DEPARTMENT OF THE AIR FORCE
AIR FORCE BASE CONVERSION AGENCY

SUBJECT: Submittal - Primary Document - Final Supplemental Investigations Report

Final Response to Comments Draft Report for Supplemental Investigations of Areas of Concern Griffiss Air Force Base Submitted November 1997

Comments on Draft SI Report sections by Dean Williams, U.S. Army Corps of Engineers, Kansas City District, Dated November 1997.

Figure 4.7-2
 SUPPLEMENTAL INVESTIGATION
 TEST PIT LOCATION MAP
 LANDFILL 7

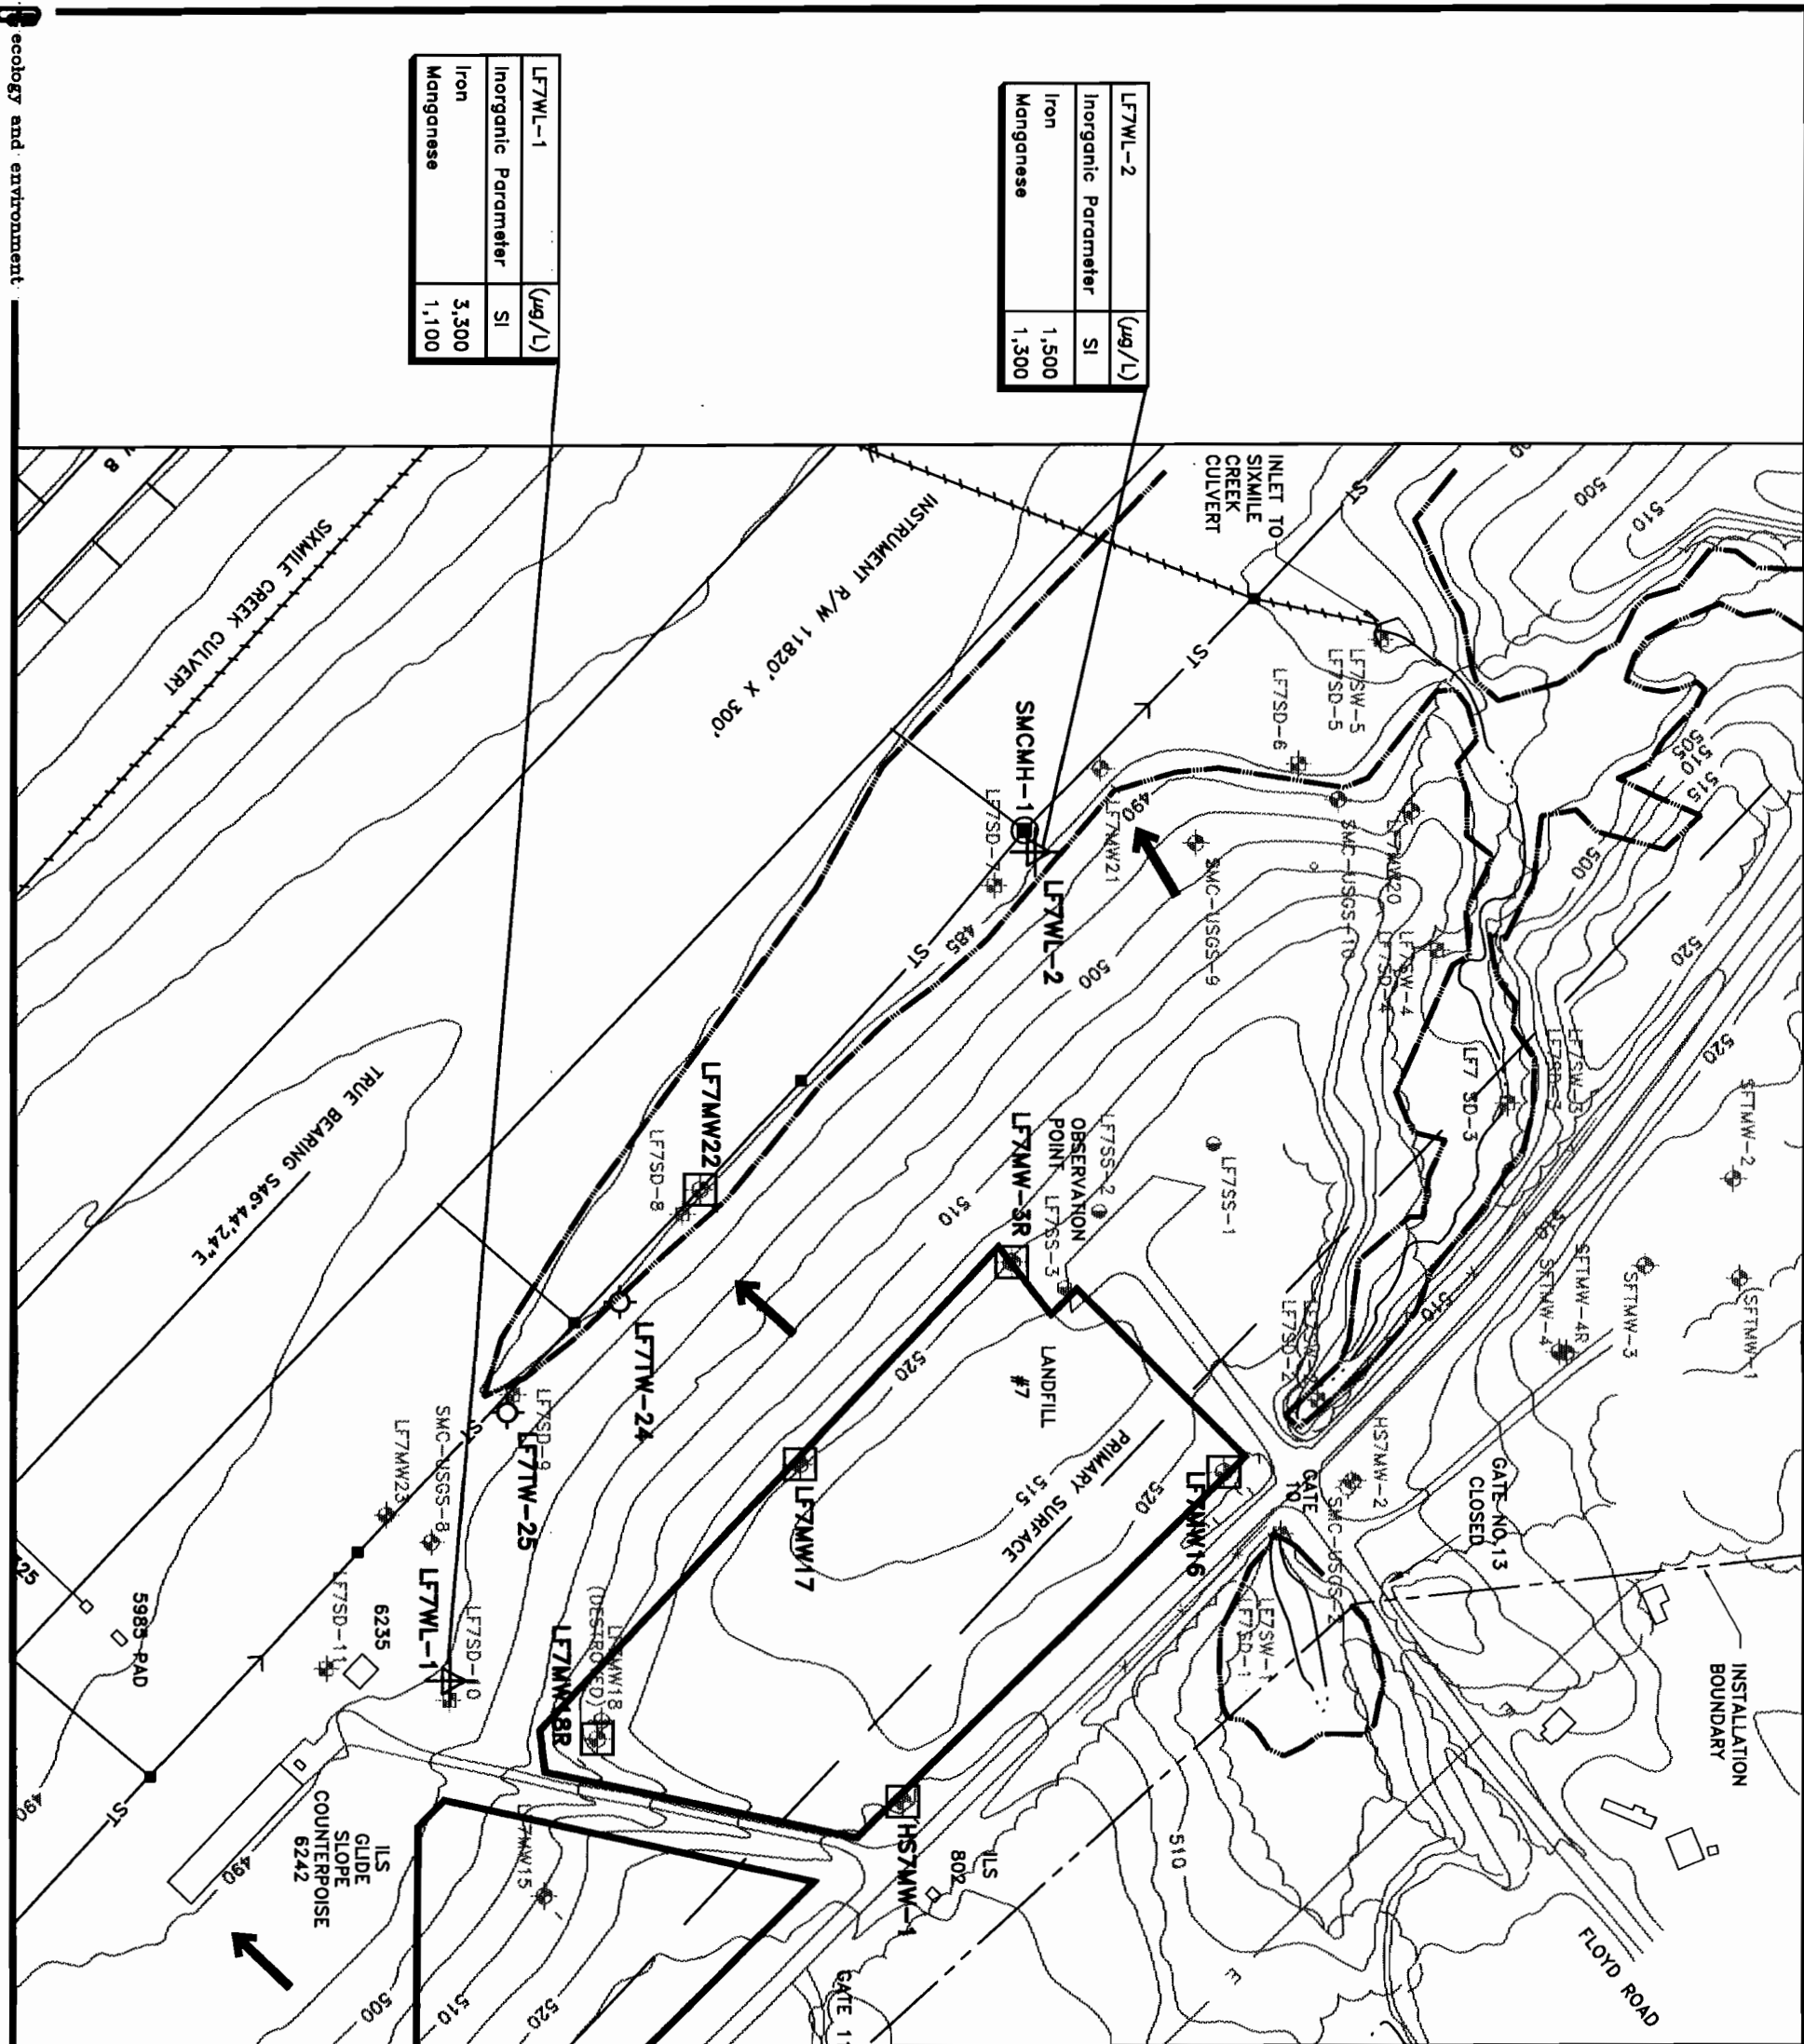
Figure 4.7-2. This figure does not delineate the Landfill 7 boundary. The figure should be updated to include the assumed landfill boundary.

Figure 4.11.4.1-1
 SUPPLEMENTAL INVESTIGATION
 SAMPLE LOCATION AND
 GROUNDWATER CONTOUR MAP
 LANDFILL 7

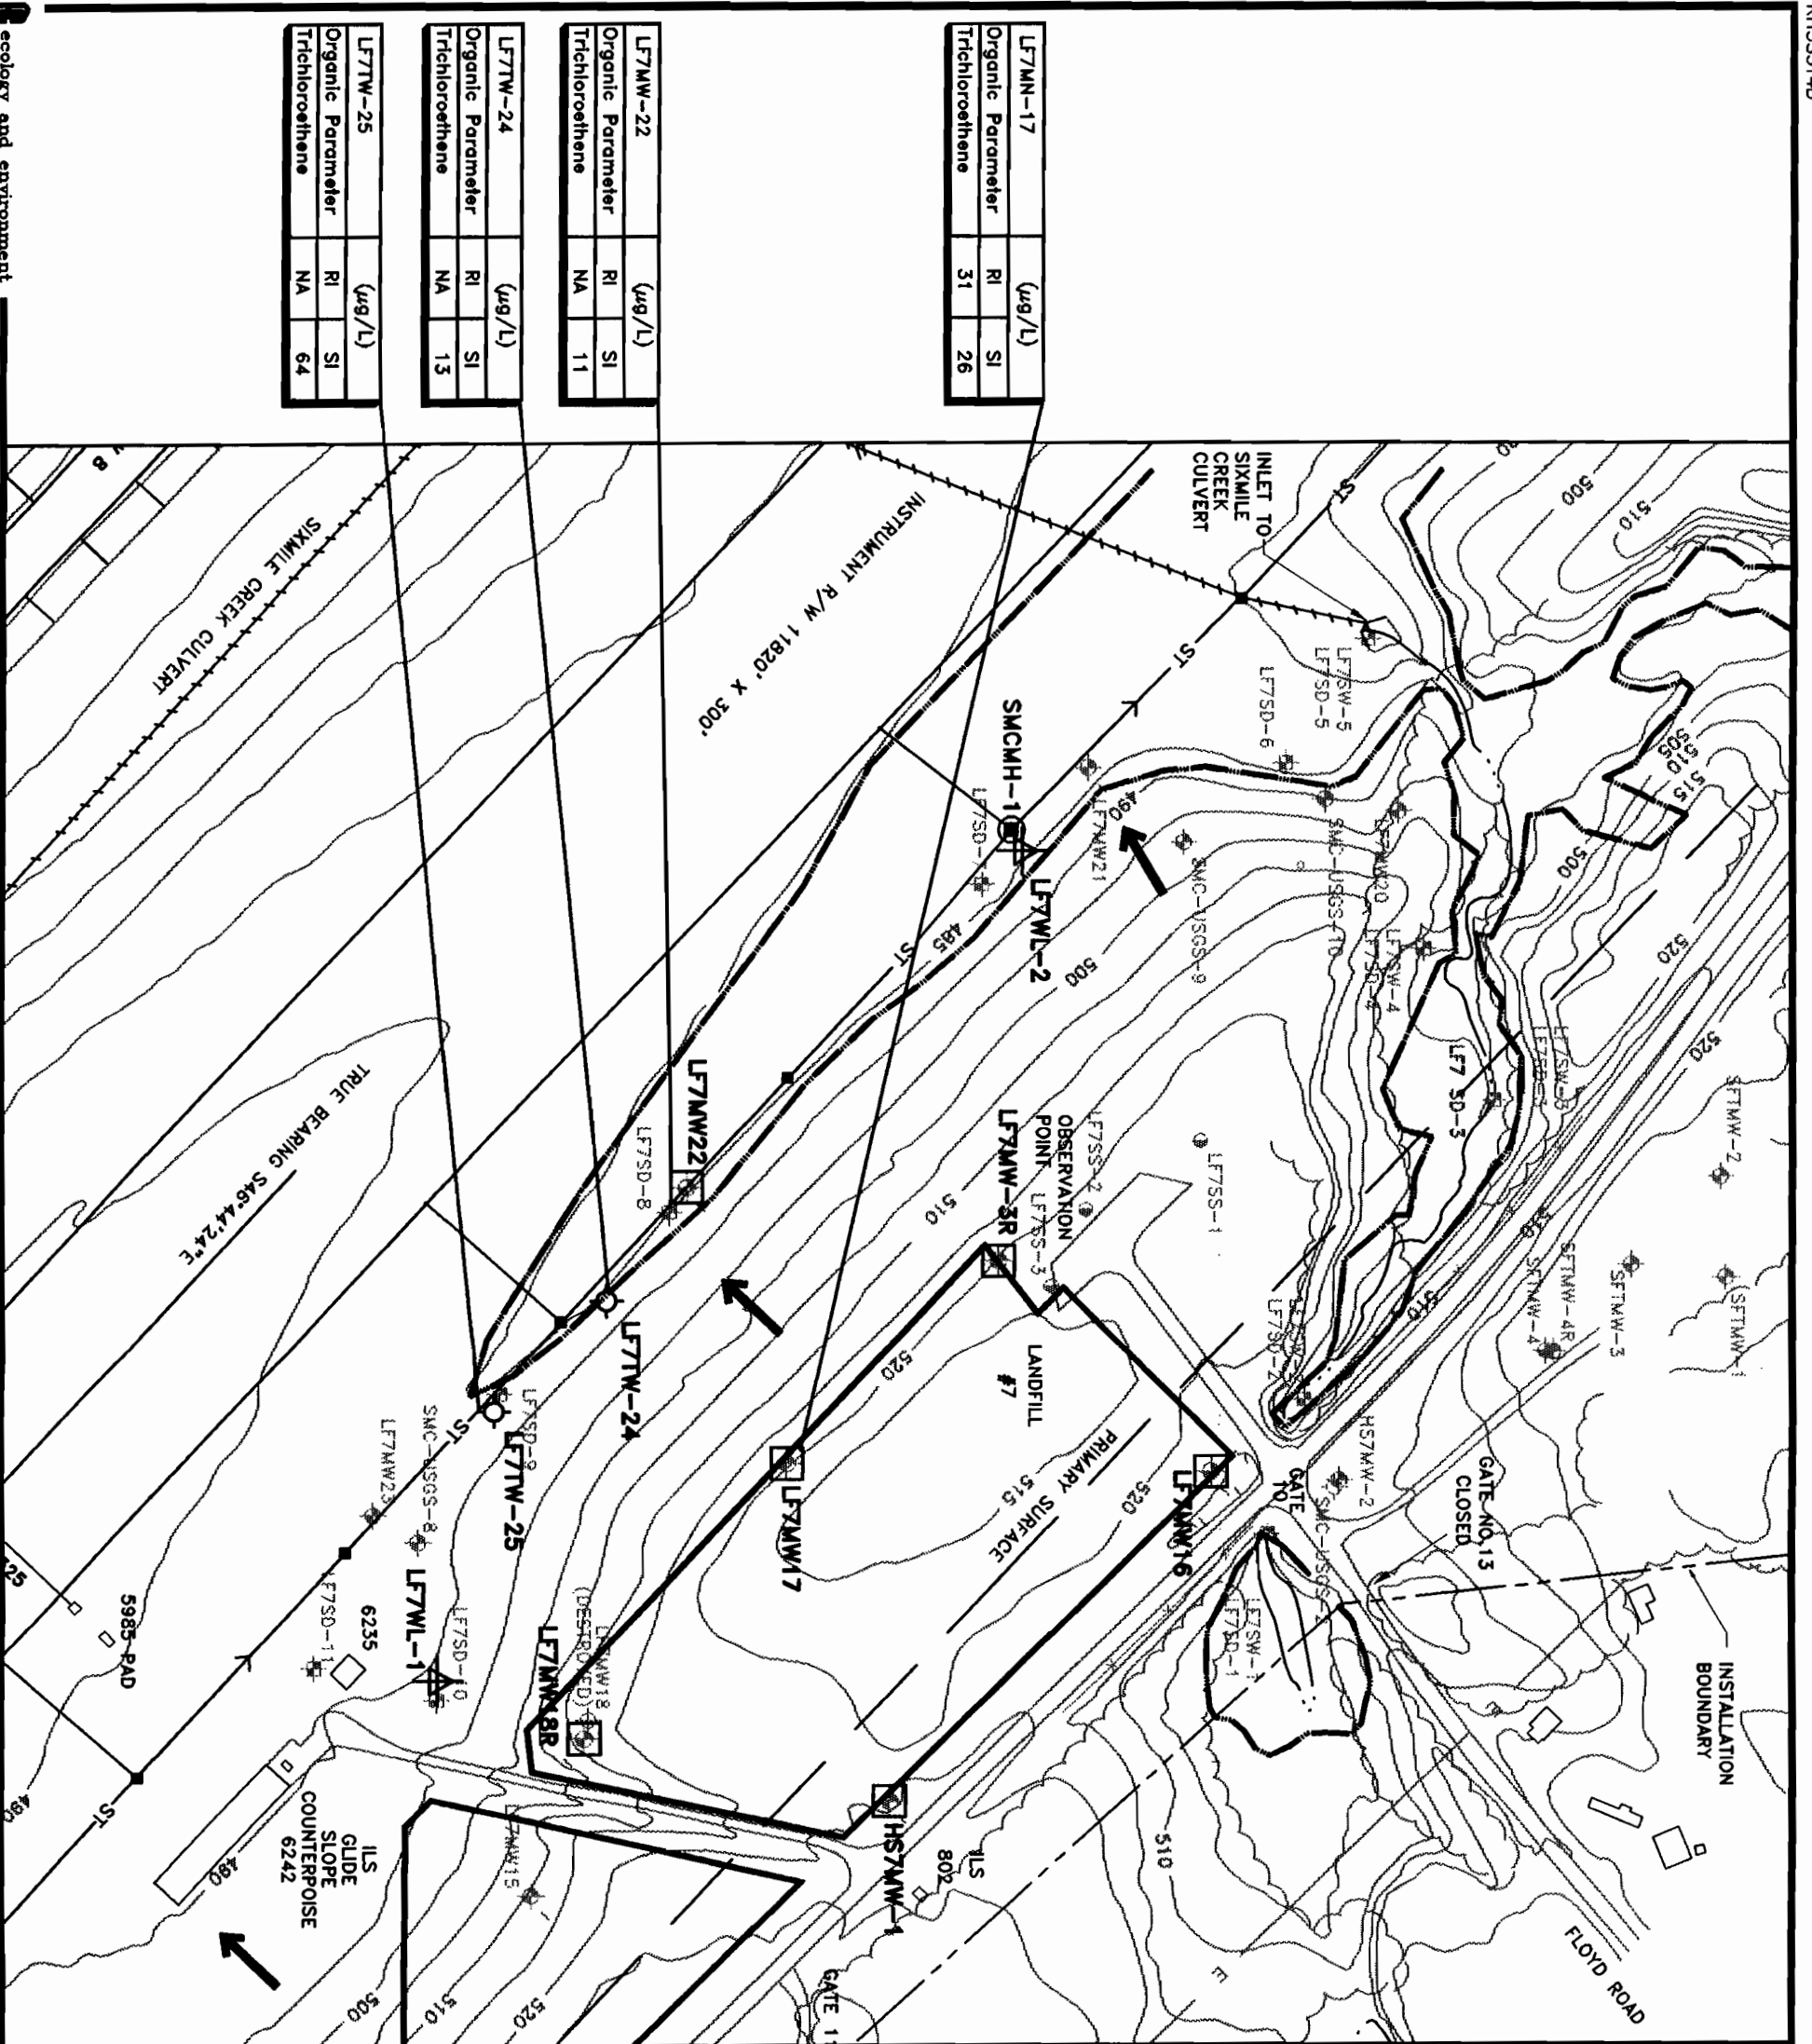
Figure 4.11.4.1-1: Modified contour line near LF7SW-2.

Figure 4.11.4.2-1
 SUPPLEMENTAL INVESTIGATION
 SAMPLE LOCATION AND
 GROUNDWATER CONTOUR MAP
 WSA AREA

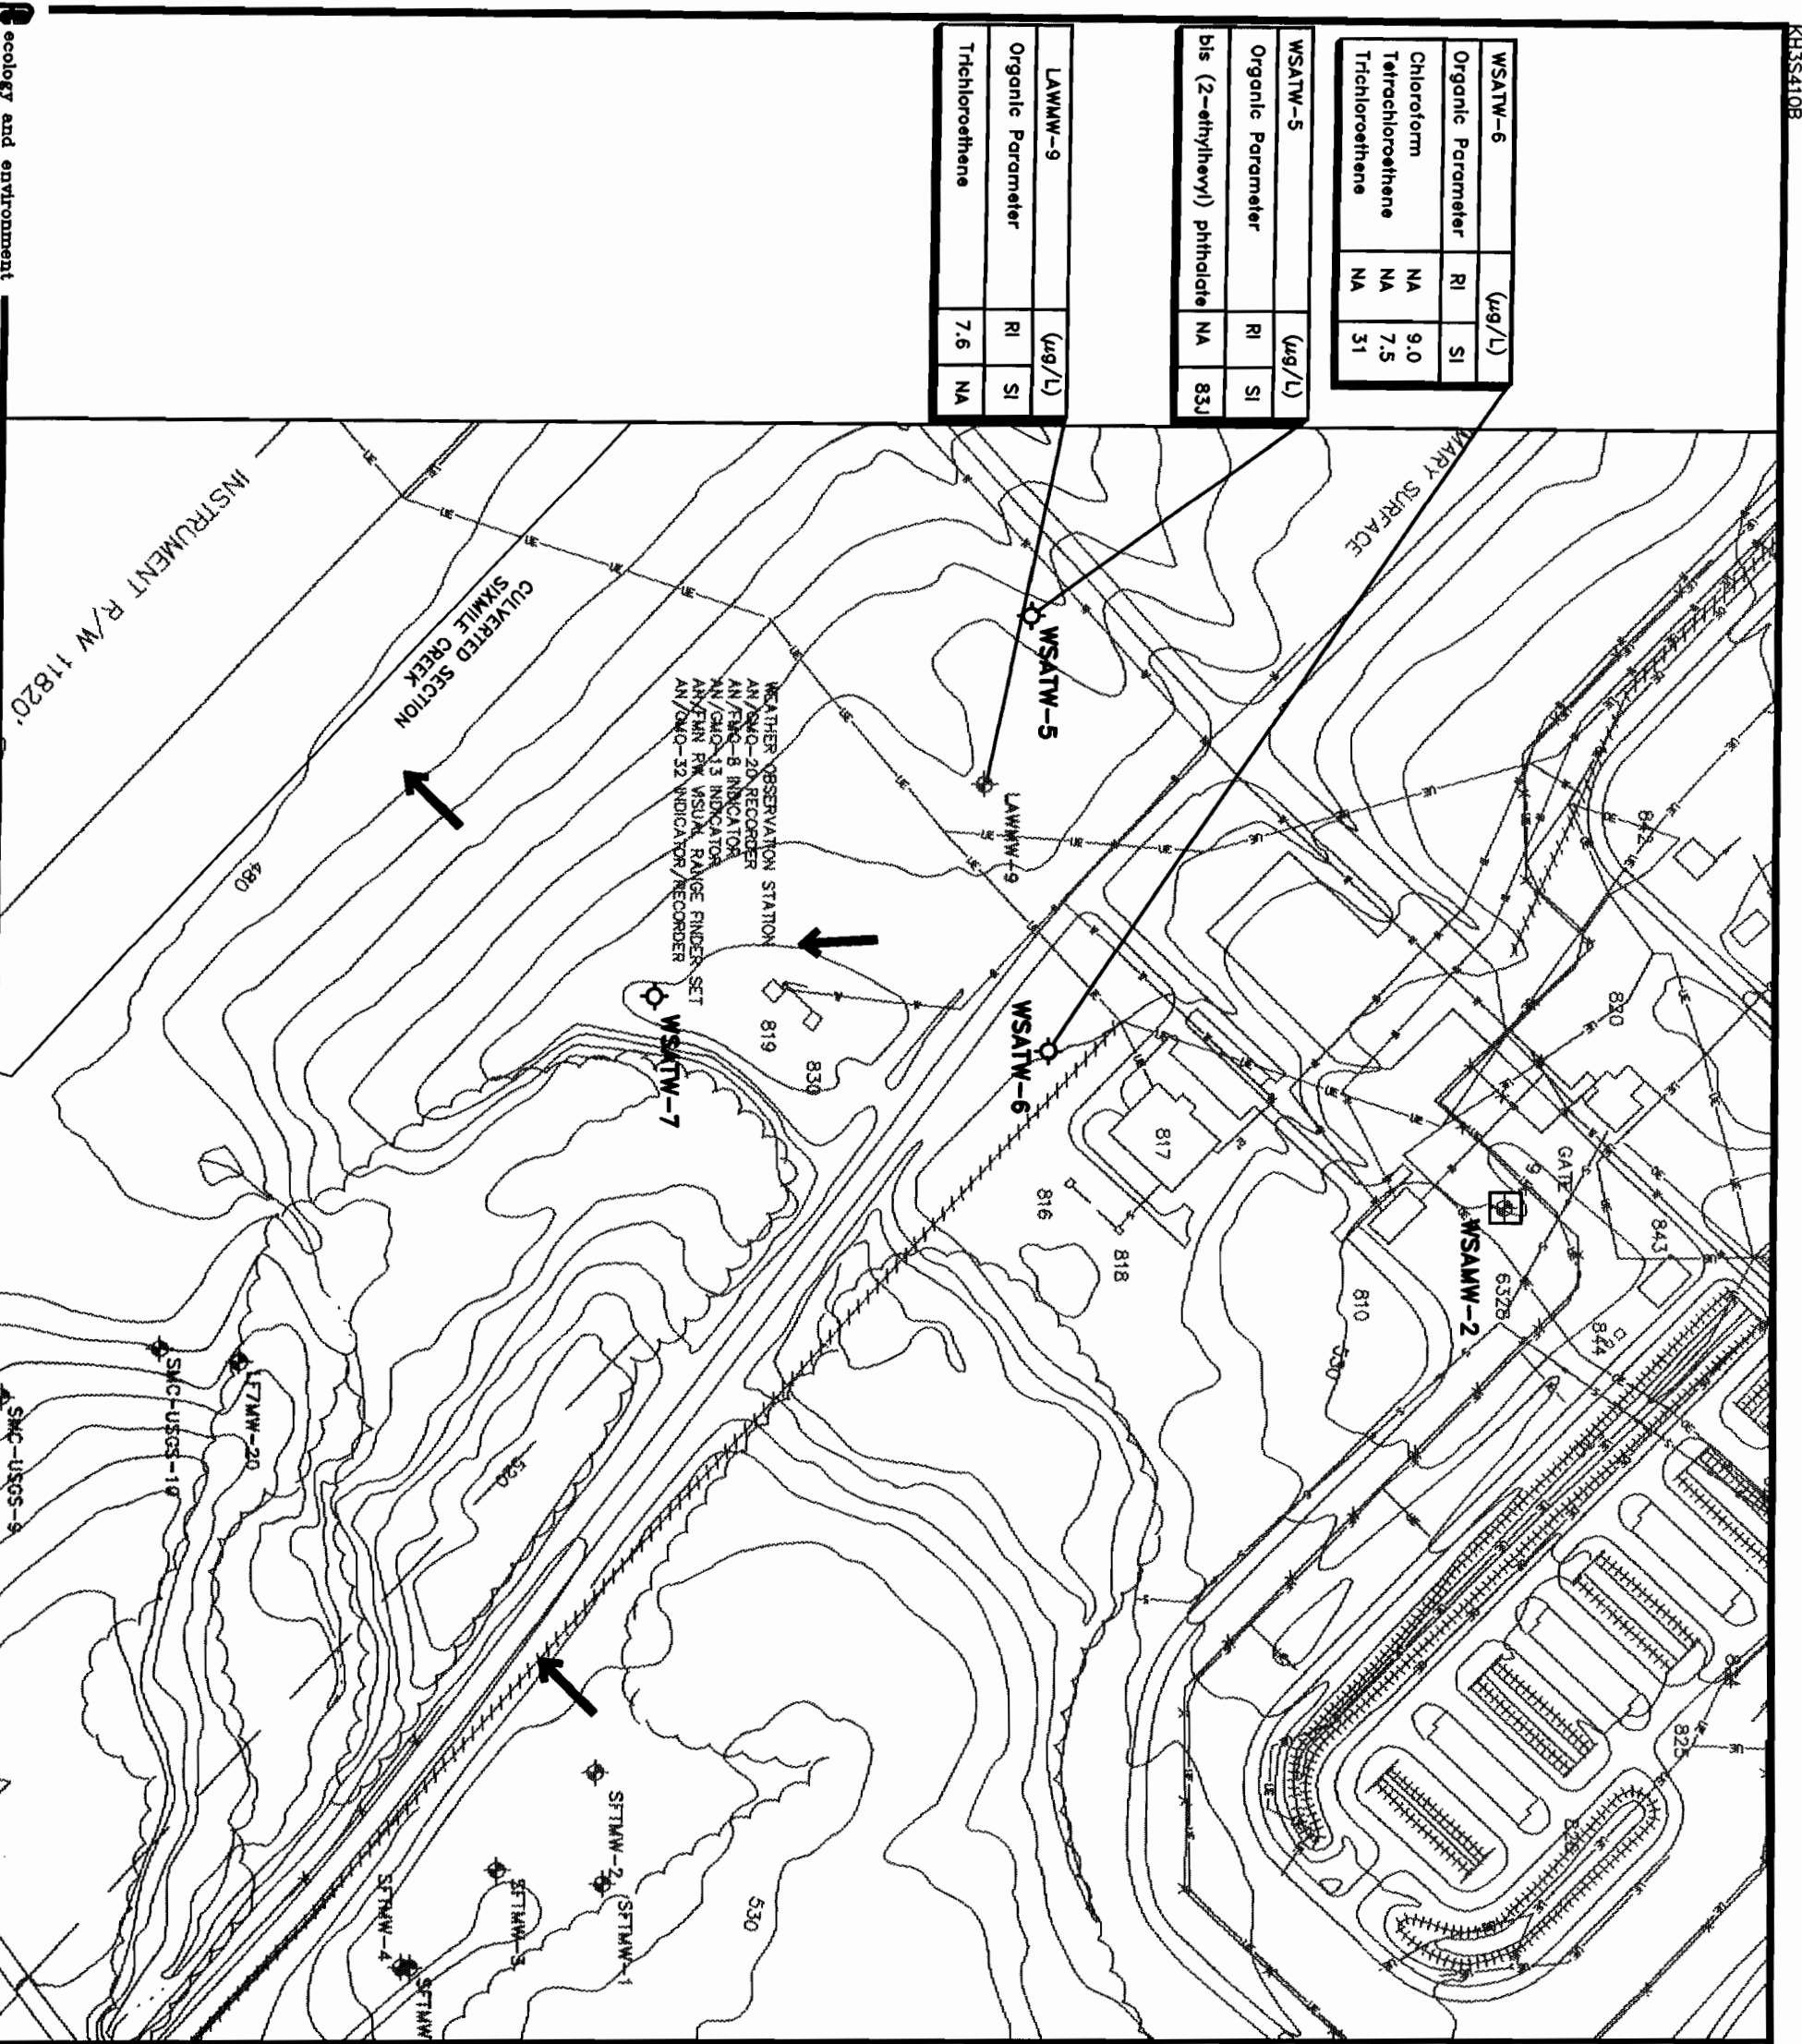
Figure 4.11.4.2-1: Modified contour lines.
